Memorandum

Subject: Case File: LU 19-225732 SOWA Alamo Manhattan Blocks
Otak Responses to Land Use Review Comments dated November 21, 2019

Otak Project No.:19050.100

ALAMO MANHATTAN
BANK STABILIZATION
PORTLAND, OR
GRADING PLAN AND PROFILE

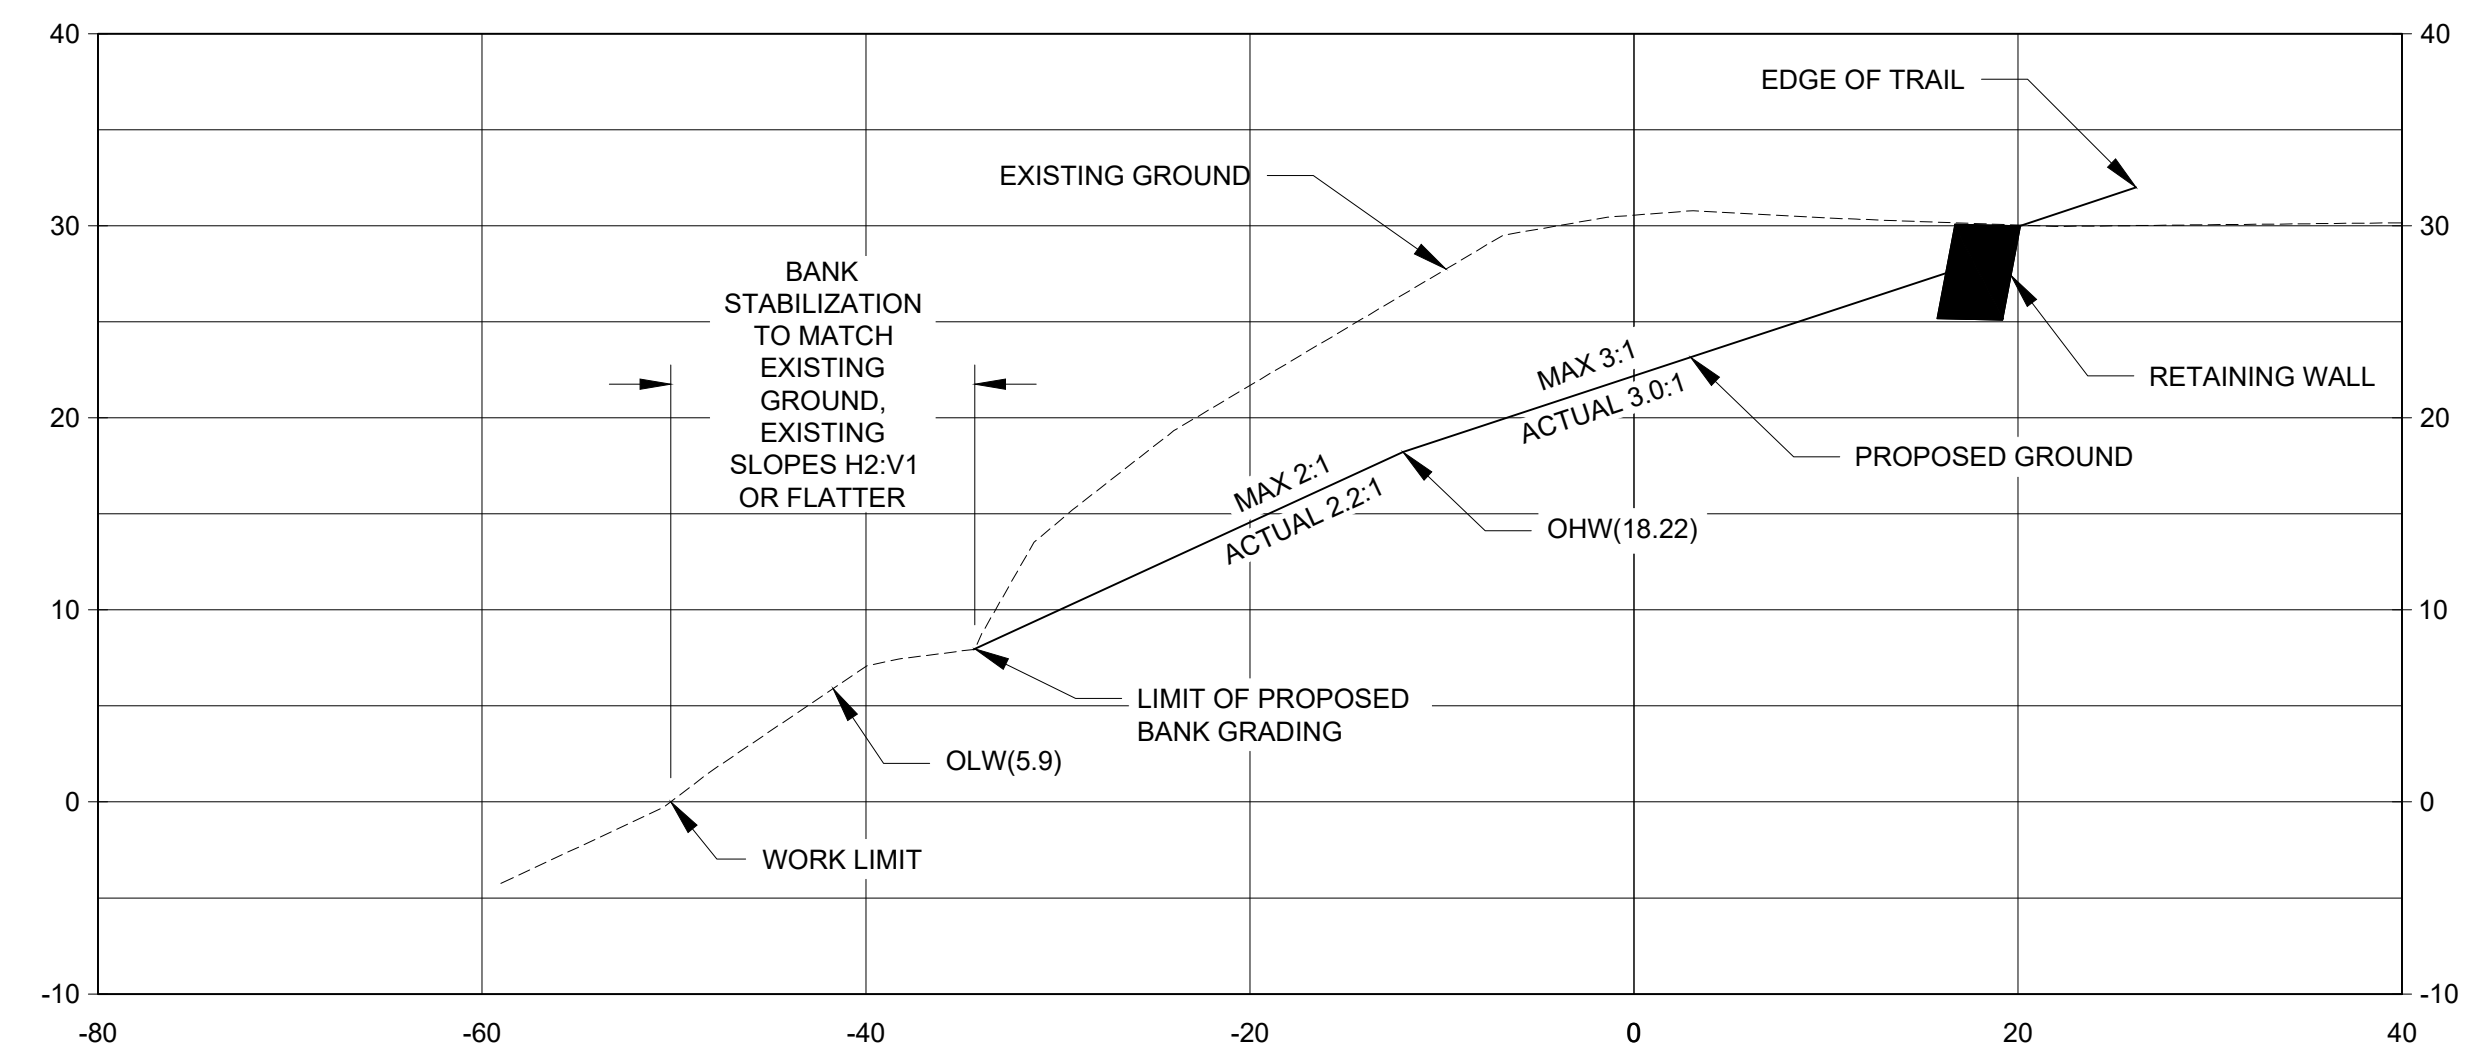
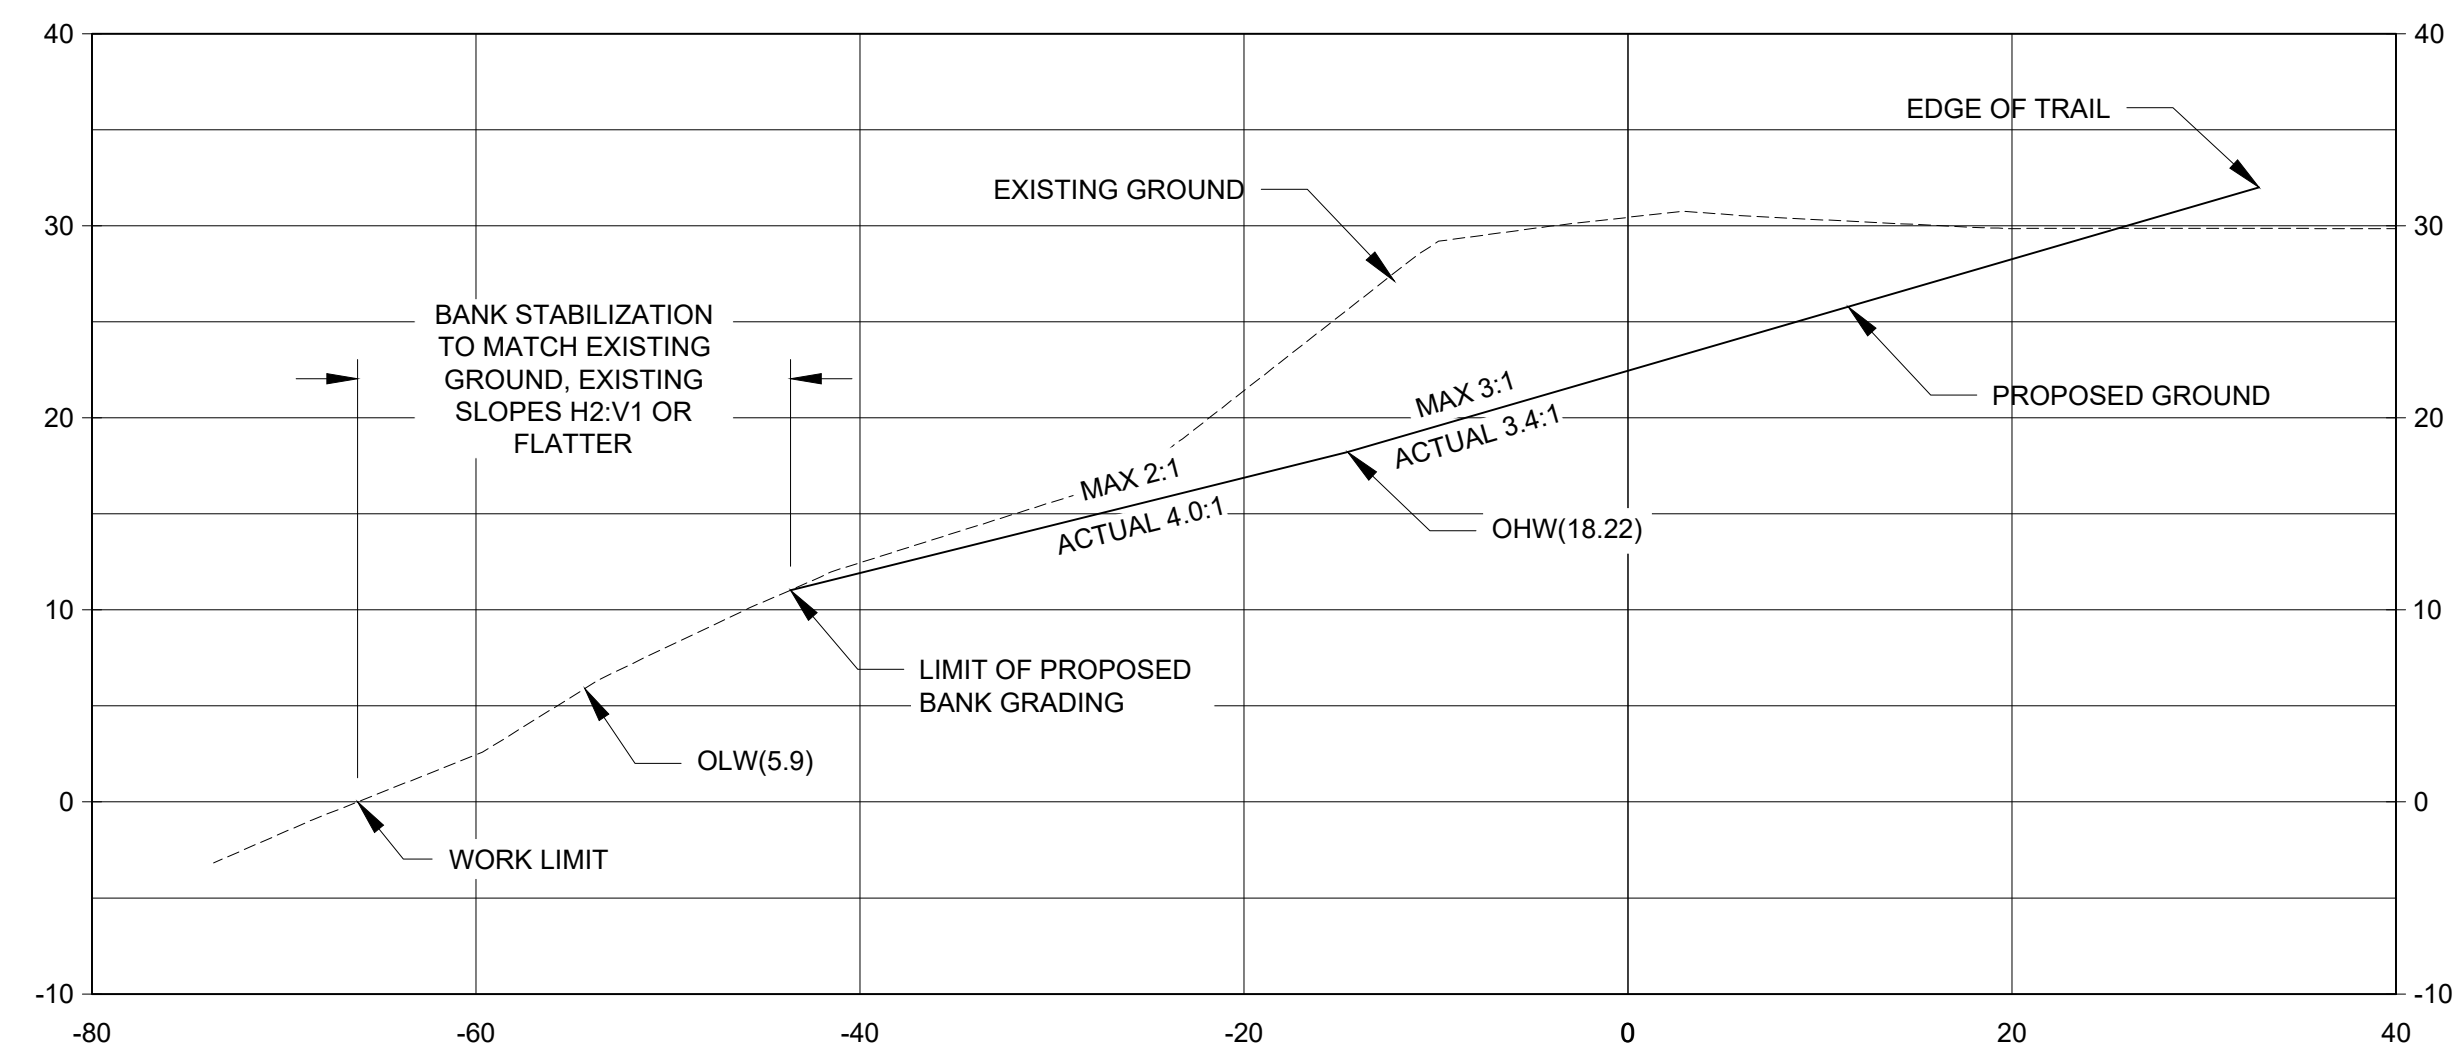
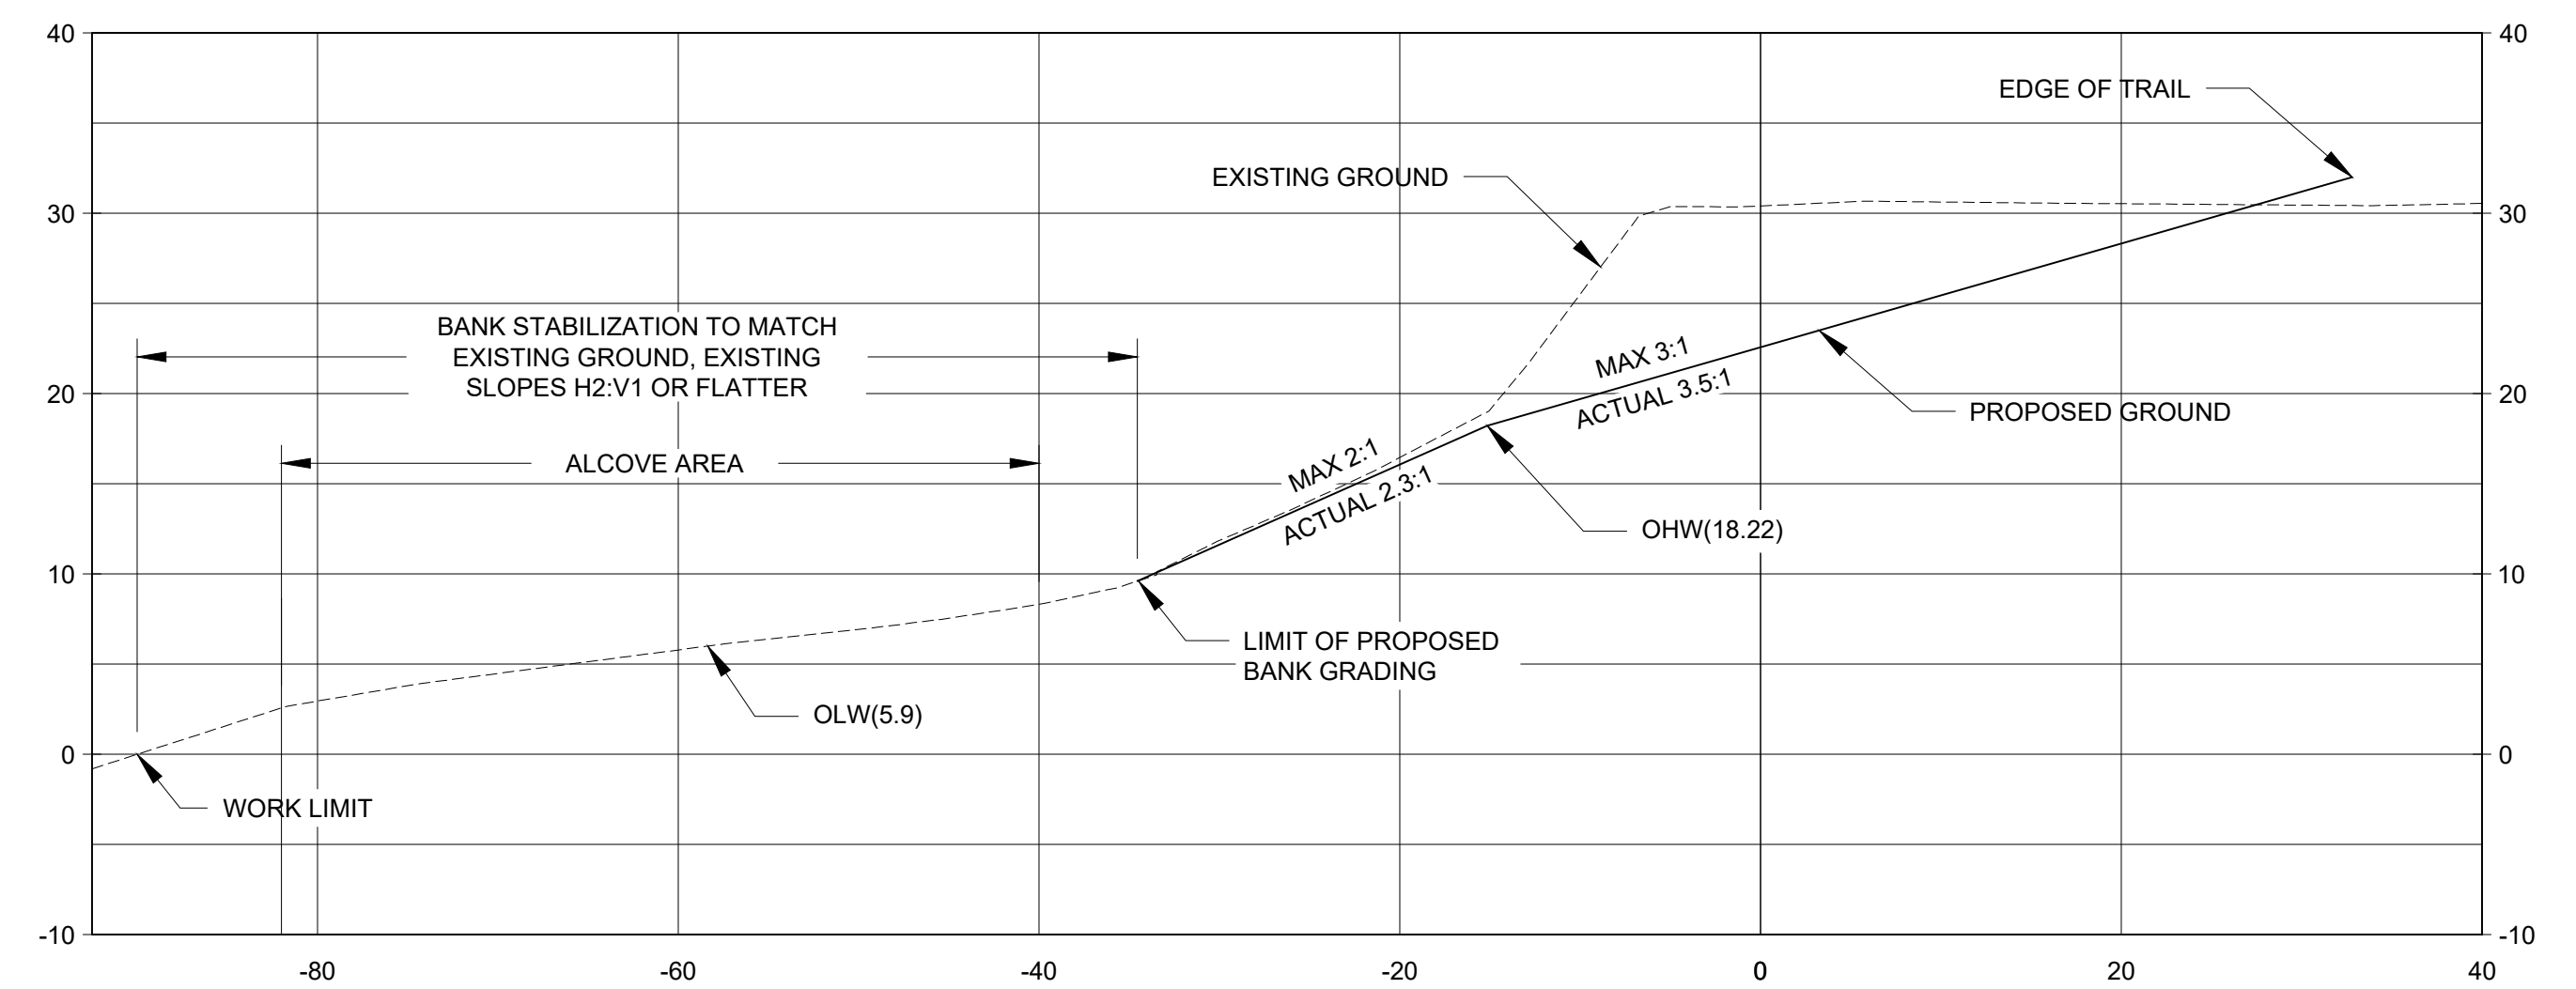
- a. *The proposal maintains a steep slope of 2:1 or 3:1 at all areas below top of bank (Sheet C2.2, C.110). This slope will require additional riprap and reinforcement. All decreases in slope appear to occur above ordinary high water (Sheet C2.2). Stable, naturalized riverbanks throughout the Willamette River are a minimum of 5:1 or shallower to 7:1 in order to allow native plantings to survive, provide adequate cover and slow moving margins for salmon to rest and rear, and to provide additional areas to escape high flows and predators. Notably, the areas of Ross Island are a 10:1 slope, Zidell was a 10:1 to a 5:1 slope in most areas, and Cottonwood bay is similarly a 6:1 to 7:1 slope below top of bank.*

The updated Greenway Review submitted is being revised to remove lawn, move the trails to the west, and create more space for bank re-grading and natural vegetation areas. Below ordinary high water the revised proposal calls for slopes between 2H:1V and 4H:1V, above ordinary high water it calls for slopes between 3H:1V and 5H:1V with some retaining wall required to prevent steeper slopes. Flatter slopes that would be required to fully naturalize the bank are not feasible due to the height of the existing steep bank and the available greenway width that must also accommodate other uses. Decreases in slope occur both below and above ordinary high water. Existing mild slopes are preserved, especially in flatter existing alcove areas at the north and south of the site (see attached plans)

Riprap is required for bank stability to protect against erosion from river flow and waves and wake. To provide cover, slow moving margins, and refuge for salmon as the water level rises, engineered large woody debris structures will be incorporated into the riprap slope. Below elevation 10 the large woody debris will be placed to create refuge and shelter, above elevation 10 large woody debris will be placed to create planting pockets for vegetation establishment because vegetation survival below elevation 10 is low even on mild naturalized slopes such as Ross Island and Cottonwood Bay. The established vegetation will provide the refuge and shelter functions. This approach is consistent with requirements of NMFS in their SLOPES V biological opinion.
